BID ADDENDUM NO. 3

OWNER: EDGEMONT SCHOOL DISTRICT

PROJECT NAME: HIGH SCHOOL RESOURCE & BUILDING E RENOVATIONS
& ATHLETIC FIELD RECONSTRUCTION

DATE: April 10, 2026

1 ROOF REMOVAL PLAN
SCALE: 1/8" = 1'-0"
0' 2' 4' 8' 16' 32'

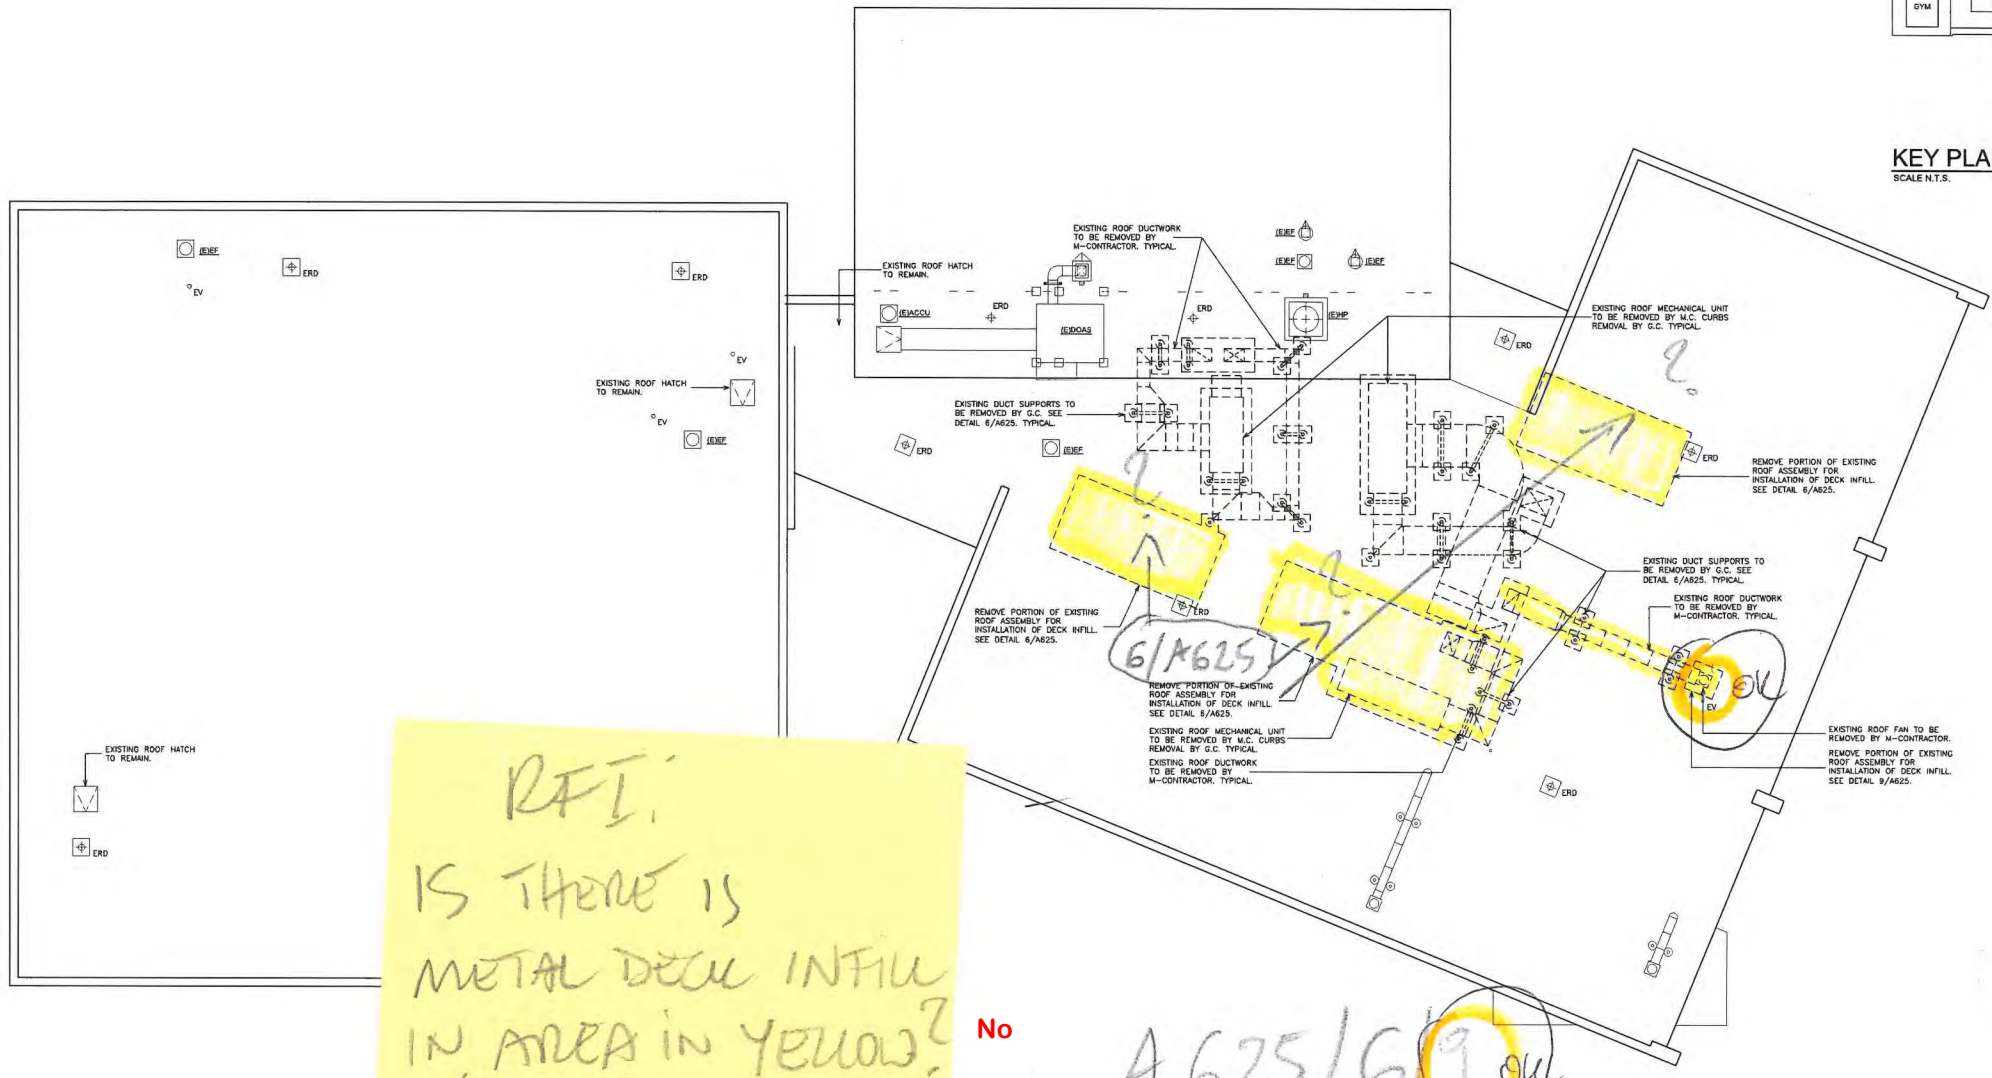
RFI:
IS THERE IS
METAL DECK INFILL
IN AREA IN YELLOW?
6/A625 SAYS (NO)
BUT
NOTE ON THIS DRAWING SAYS
DECK INFILL

REVISE note “Remove portion of existing roof assembly for installation of deck infill. See detail 6/A625” to read “Remove portion of existing roof assembly for installation of mechanical roof curbs. See detail 6/A625 for typical splice detail.”.
